LR-N16-0120

Subject: Salem Generating Station Unit 1 Compliance with March 12, 2012 NRC Order Modifying Licenses with Regard to Requirements for Mitigation Strategies for Beyond-Design-Basis External Events (Order Number EA-12-049) and Final Integrated Plan for Units 1 and 2

Attachment 2: Salem Generating Station Units 1 and 2 Response to NRC FLEX Audit Items

Figure 2: FLEX Canyon Layout (PSEG Drawing 606424, sh.1)

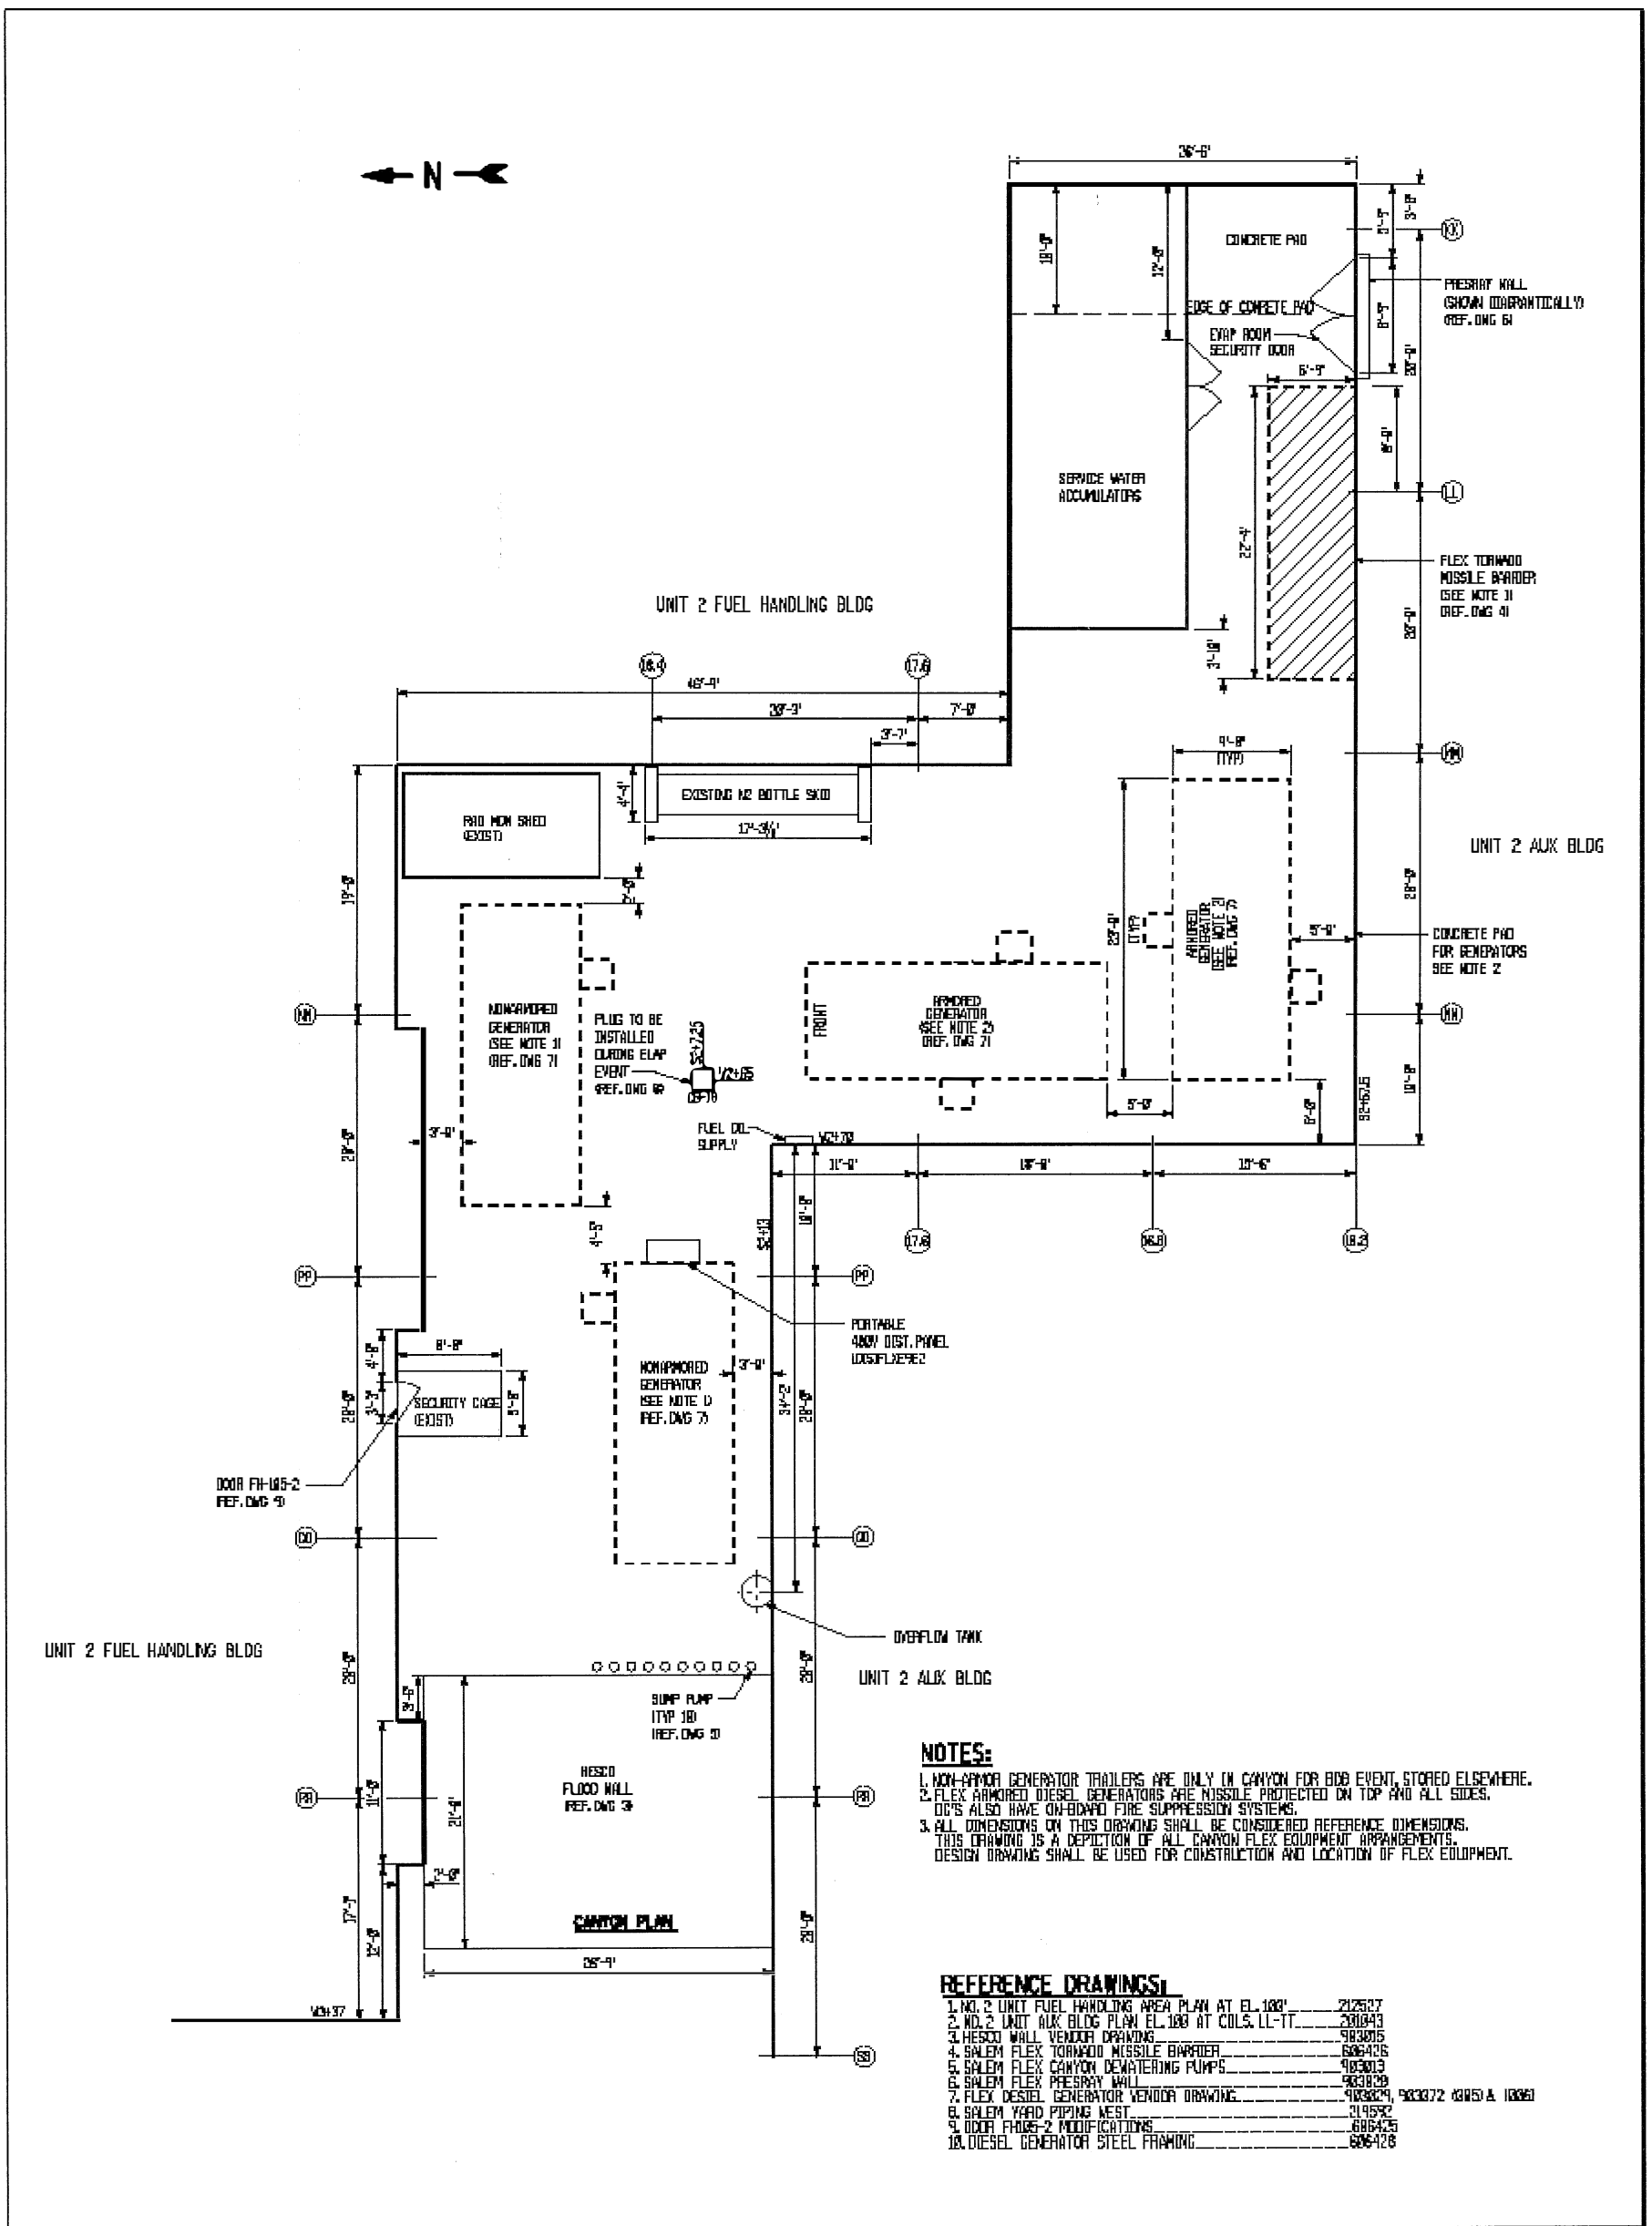
Provide an evaluation of the susceptibility to damage for the FLEX generators. Demonstrate that the construction of the canyon wall is viable.

Pre-staging the two FLEX DGs in the Canyon Area is an alternative to NEI 12-06 Revision 0, which describes the use of portable equipment. The FLEX DGs in the Canyon Area are shown in Figure 2 of the enclosed FIP. They are protected from all NEI 12-06 external hazards. The pre-staged FLEX DGs are hardened ("armored" as shown on FIP Figure 2) with missile protection on the top and all sides, and are provided with bracing systems to resist seismic and wind loads.

Figure 3: BDB FLEX Electrical Strategy (Page 1 of 3)

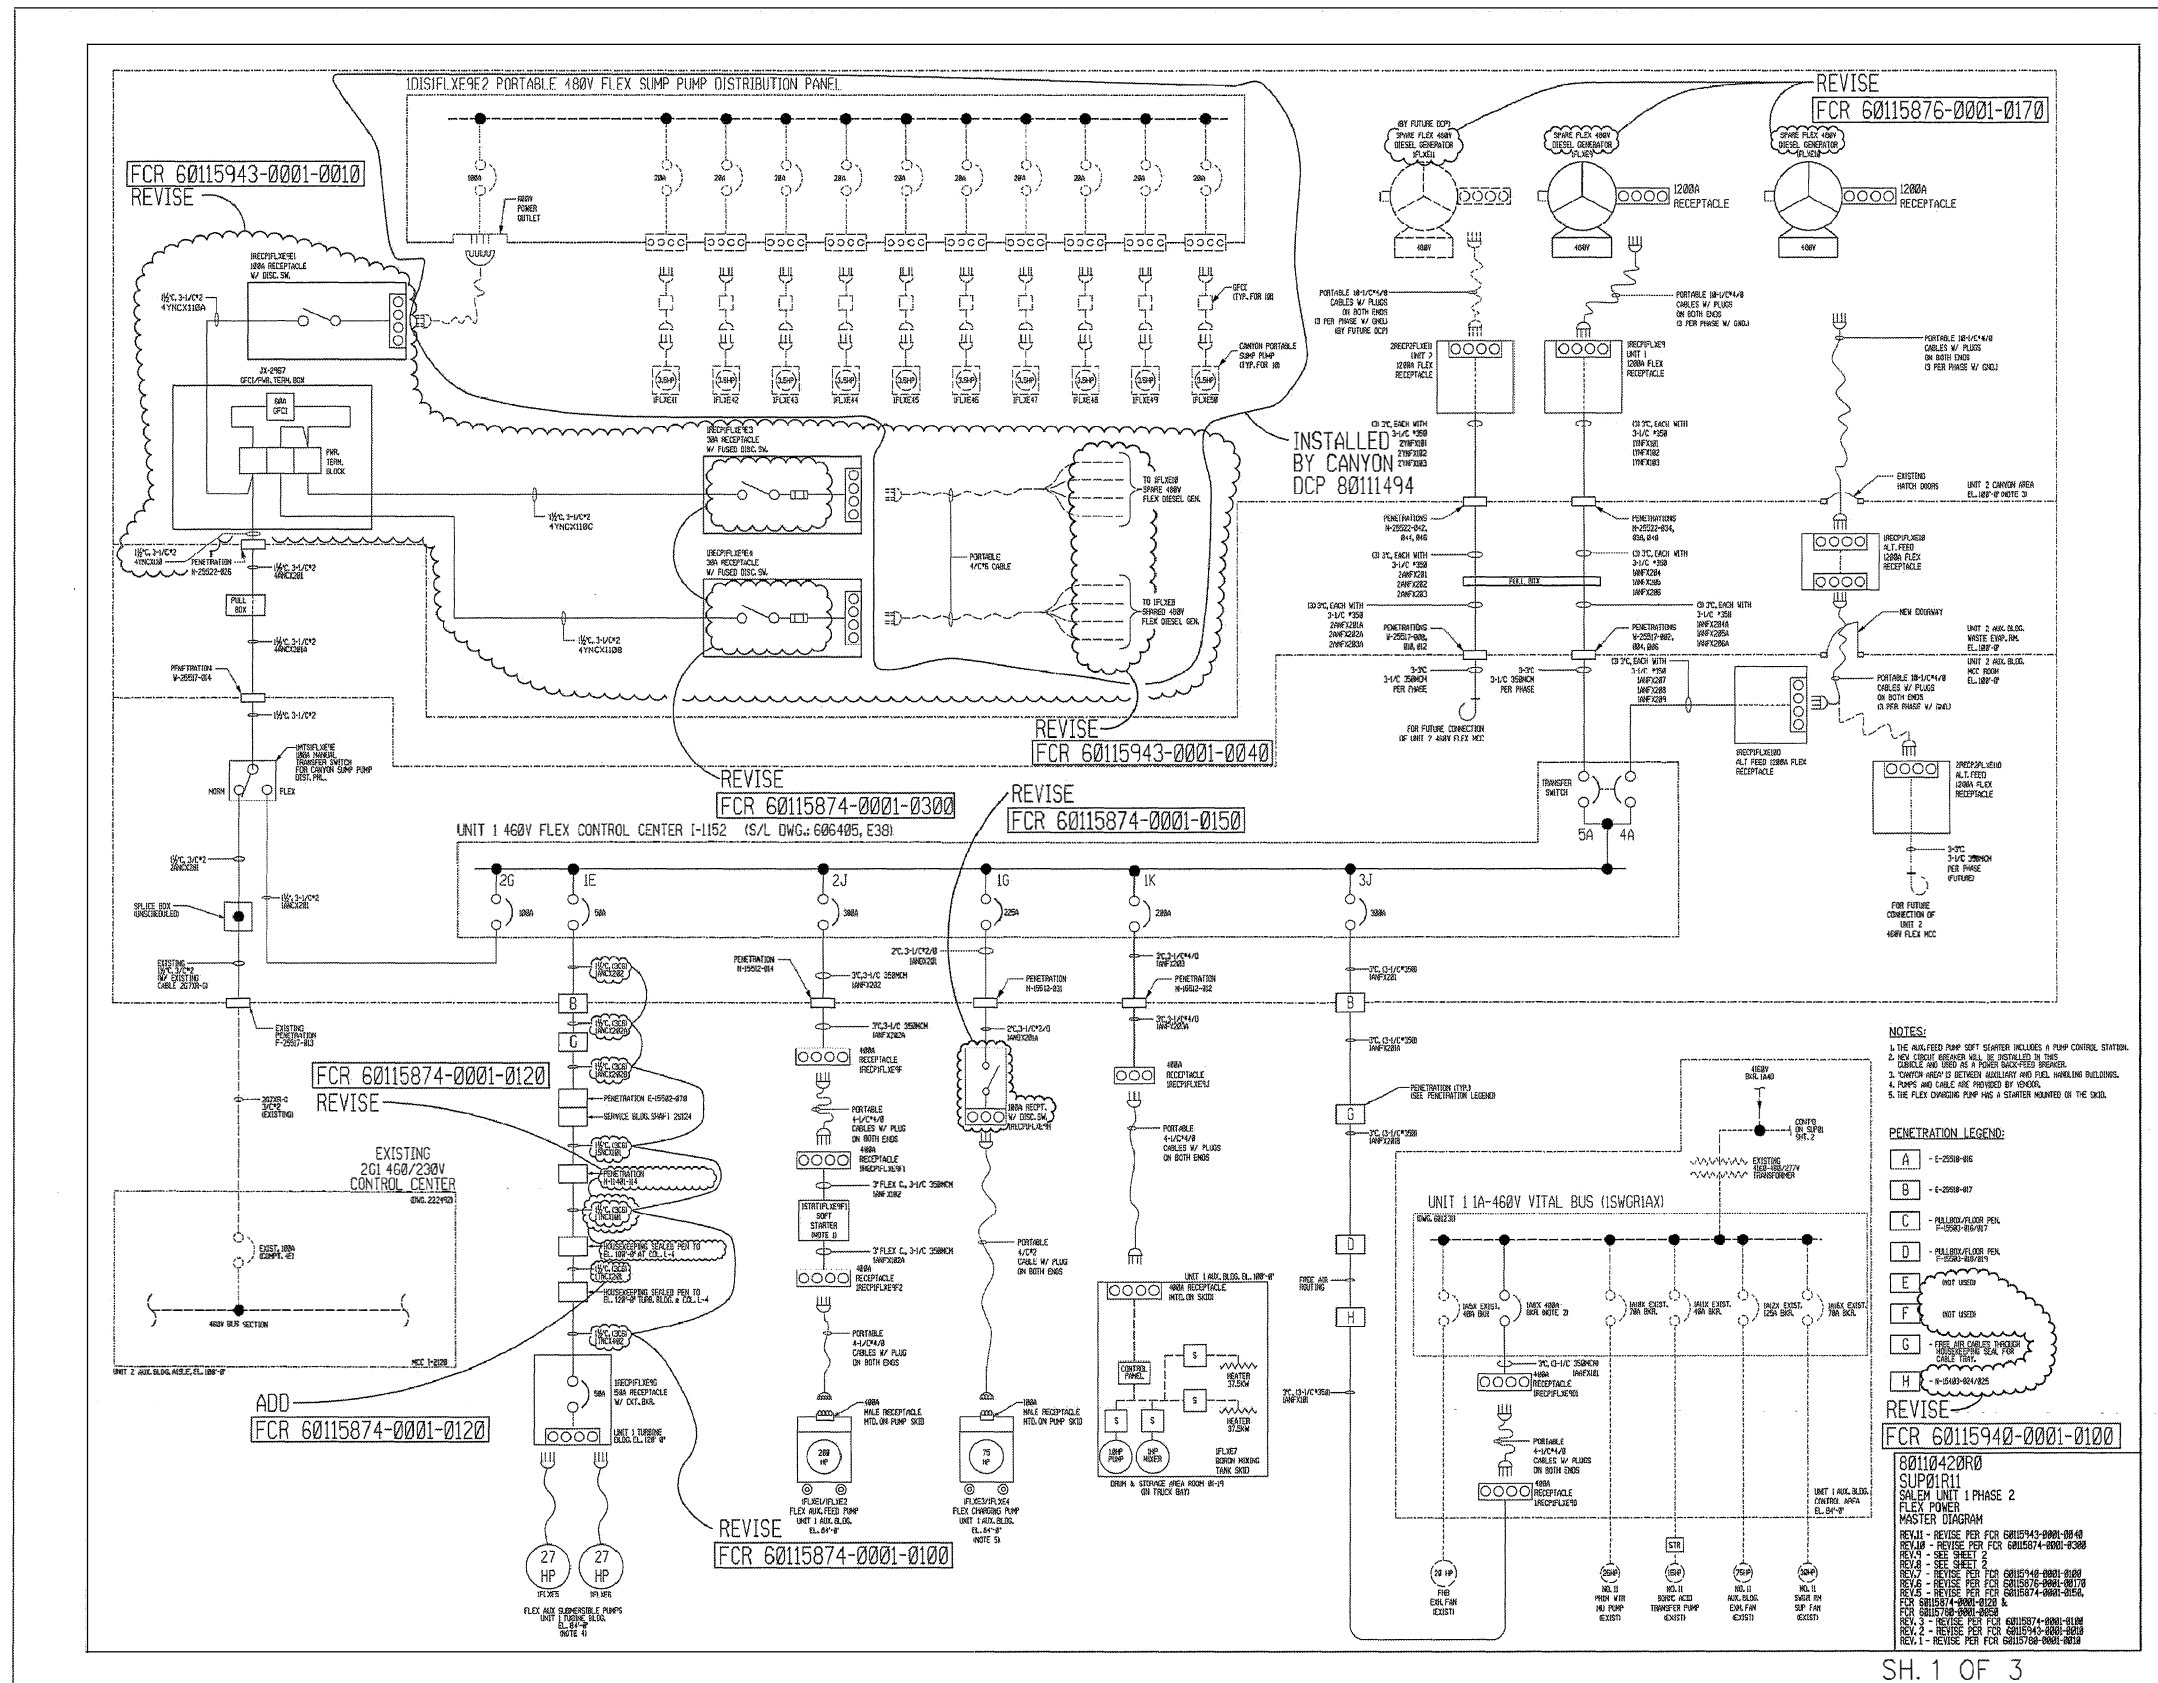
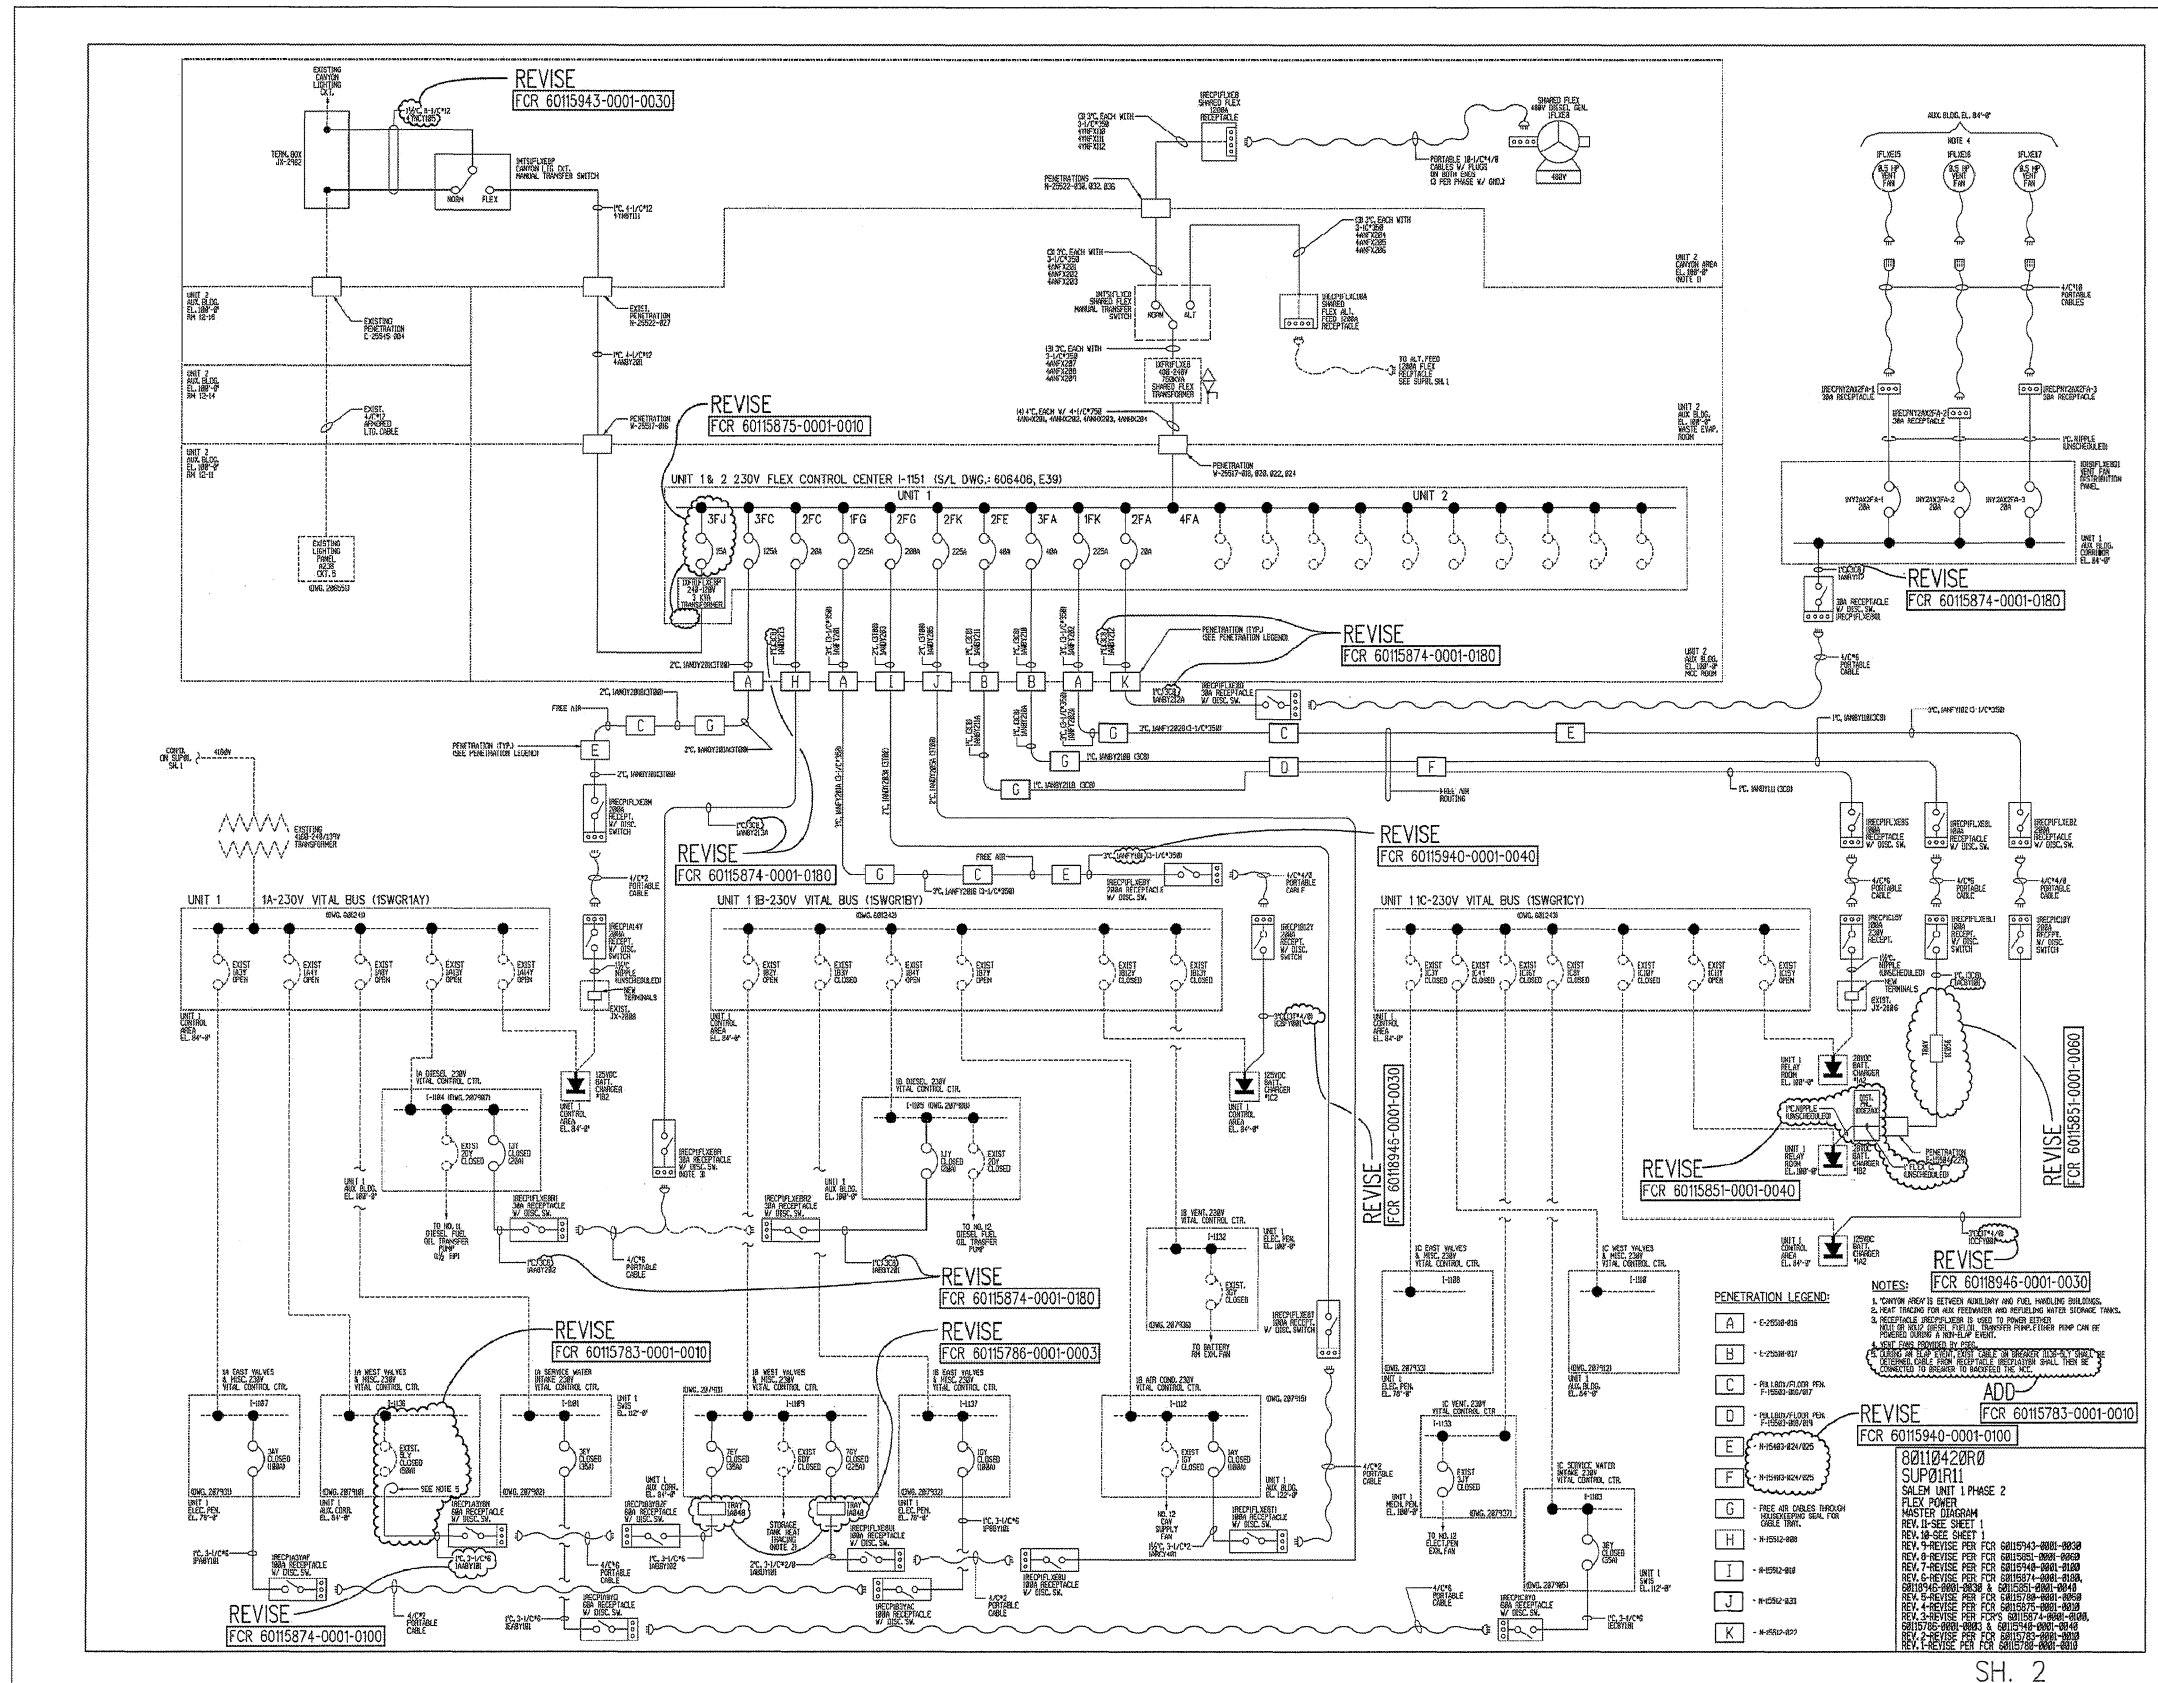
The licensee should provide the single line diagrams of the proposed electrical systems. As part of this item the NRC audit report (Reference 3) requested PSEG to address potential personnel hazards regarding the orientation of disconnecting blades in the FLEX power receptacles.

PSEG provided the single line diagrams as part of the audit process, and they are included in the enclosed FIP. PSEG provided the following information in response to the personnel safety aspect of this item:

- If the FLEX bus is the power source, the power cable to the disconnect is wired to the stationary side (non-blade side).
- If the plant bus is energized (normal configuration, no ELAP), the plant equipment is wired to the stationary side (non-blade side) of the disconnect.
